ADDENDUM NO. 3

POLYTECH HIGH SCHOOL  
RENOVATIONS AND ADDITIONS  
BID PACKAGE 'A'

This addendum is hereby made part of the Project Manual and Drawings dated 9 July 2012.

**CSK059**

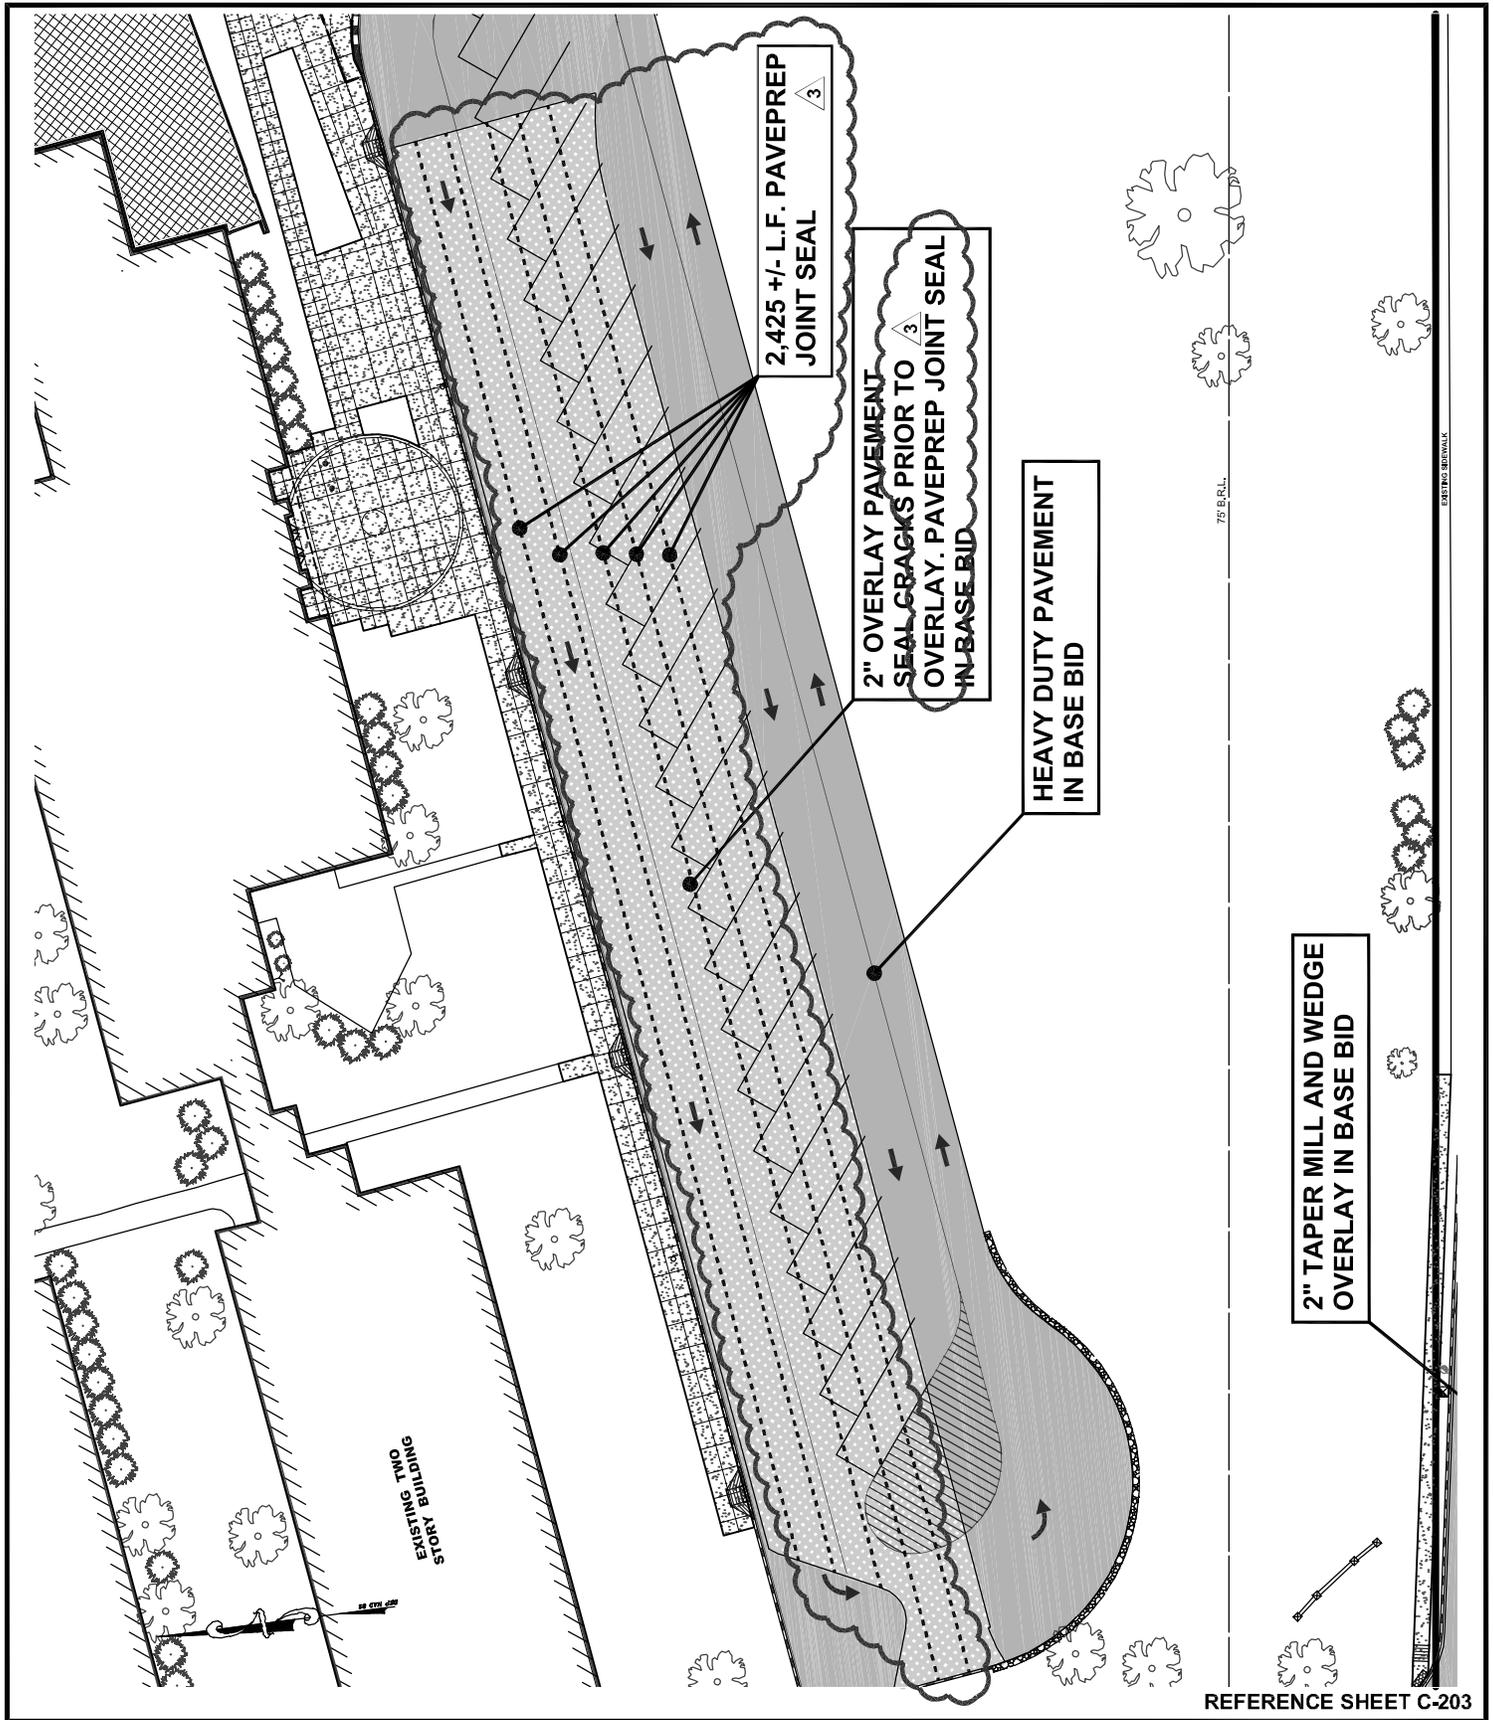
- A. **C-201 Site Plan** - Drawing revised as indicated on sketch CSK058 and included with this addendum.
- B. **C-202 Site Plan** - Drawing revised as indicated on sketch CSK059 and included with this addendum.
- C. **C-203 Alternates 2-7 Site Paving Plan** - Drawing revised as indicated on sketch CSK060 and included with this addendum.
- D. **C-504 Sediment and Stormwater Management – Bioswale 1, 2 and 3 Plan, Profile & Section and Constructed Wetland Section** - Drawing revised as indicated on sketch CSK061 and included with this addendum.
- E. **C-505 Sediment and Stormwater Management – Bioswale 4 Plan, Profile & Section, S.W.M. Section & Outlet Structure CB-6 Detail** - Drawing revised as indicated on sketch CSK062 and included with this addendum.

5. On sheet C-201 the only pavement called for "mill & overlay" is on Walnut Shade Road which does not require Pavprep. However, the "overlay" in the bus parking area at the front of the school does require repair of longitudinal cracks using Pavprep. See CSK058, CSK059 & CSK060 which area attached.
